## **Design, access and heritage statement**

Application for removal or variation of  
a condition following grant of planning  
permission

Erection of a single storey rear extension  
and the provision of new front lightwell stair,  
together with internal alterations including  
enlargement of openings in lower ground  
floor rear room wall

**40 Downshire Hill, London NW3 1NU**

**Lower ground floor plan as consent**  
(not to scale - refer architectural plans for more detail)

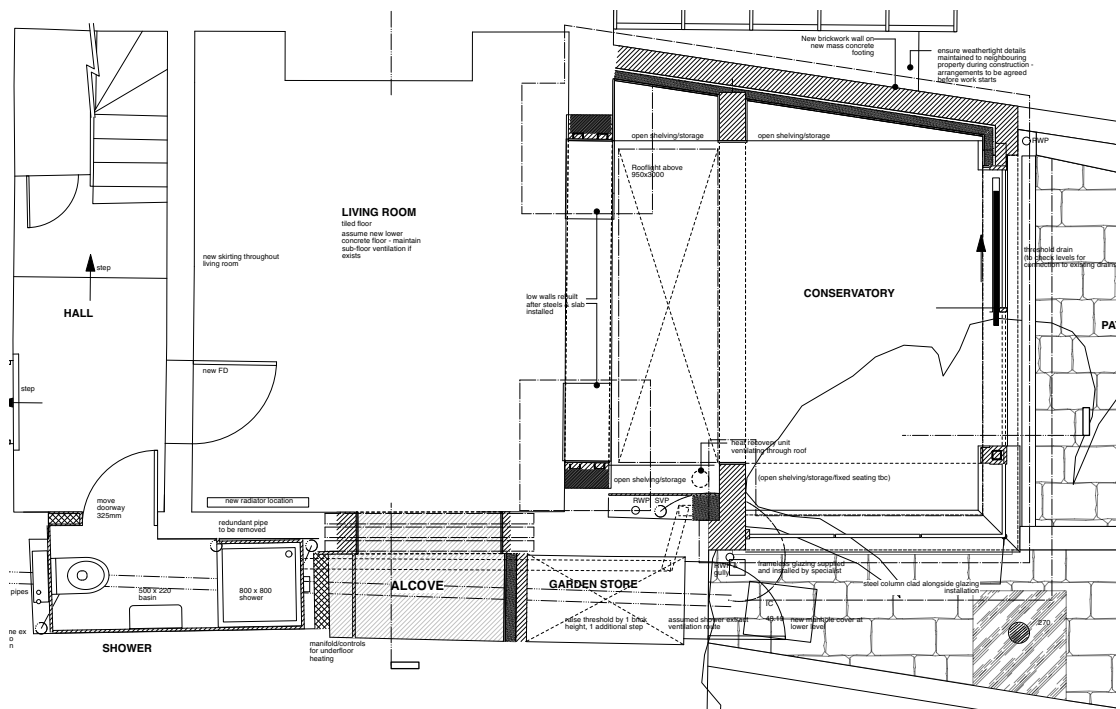
- 1.3. An application to discharge the details relating to railings is dealt with separately as discharge of condition.
- 1.4. Layout alteration:
  - The WC/shower room at lower ground floor level needs to be constructed at lower level have a viable ceiling height. This means extending the lower floor level currently indicated on consent and lowering the shower tray locally.

- As the structural opening in the rear wall indicated on consent drawings involves 2 slender piers it would need a beam spanning the 3 openings, with the 2 piers purely acting visually rather than structurally, and would need reconstructing, rather than retaining original structure. It is therefore more logical to make better use of a more open view towards the garden. A small, low level section of wall can be retained either side of the opening retaining the sense of the principle rear elevation wall beyond which new construction starts. Overall this change is a reduction in the overall width of the structural opening required.

- The consented route to the rear garden via a library to the side abutting no. 40A is impractical to construct as it would imply significant lowering of the drains present in this area, as well as providing an access route surplus to requirements. This amendment implies less construction work in this area. Retaining a part of the existing garden store is also useful.

- 1.5. Door and window alterations:
  - 1 single sliding rear garden door in aluminium is proposed rather than 2 doors, the side door to be omitted. This also provides a much improved visual link between the lower ground floor rooms and the garden beyond.

- 1 single rooflight, which opens to provide ventilation provides natural daylight in the most useful area. A slightly reduced level of glazing overhead helps thermally without compromising outlook.
